City of
Richmond

Report to Development Permit Panel

File: DP 21-928686

Re: **Application by Urban Design Group Architects Ltd for a Development Permit at 10980 No. 3 Road**

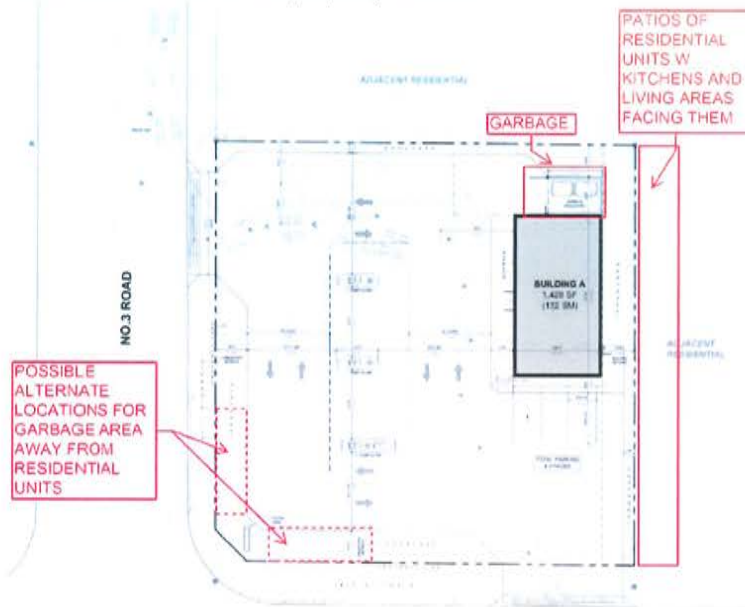
- Fence. The current design proposes a chain link fence with small trees / shrubs planted in front. A fence of a material that would protect against fire hazards (such as concrete) should be considered for safety. Fence ideally would not be higher than the existing residential fence. Existing wood fence is 5'-8" high.

- **Landscaping.** The current design proposes a very small landscaped area between the properties. It goes from 10'-0" at its widest to only 3'-4" wide along the east edge of the project site. The current design will not assist in mitigating smells, noise, and light pollution. We ask that a wider strip of landscaping (15'-0" wide or more) be designed instead and run along the entirety of the east edge of the site. We also ask that more mature trees be installed beside the fence that are high enough (10' to 12' tall) to make mitigation of issues possible.

- **Garbage.** As seen above, the current design proposes the garbage area be located north of Building A, directly adjacent to the residential units. We ask that the garbage area be moved away from the north and east edges of the property, where residential units would be adjacent. Garbage could be located at the south west corner of the property instead.
